Northern Technologies

Product Enhancement Announcement

June 28, 2018

CHANGE WILL BE AS FOLLOWS:

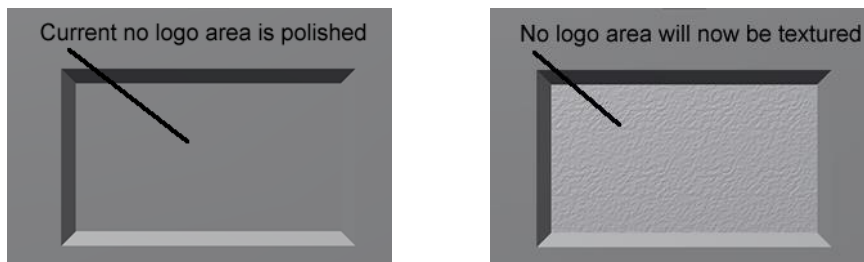
The no logo insert area of our standard plastic CPP gray, plastic CPP black and metalized plastic CMP series connector covers will be changing from a polished area to a textured area.

This will help hide any imperfections due to packaging of plastic or during the rinse spin cycle of metalized plastic connector covers.

This will not affect the form, fit or function of the part and is strictly to reduce the number of visual scratches in the connector cover blank logo area.
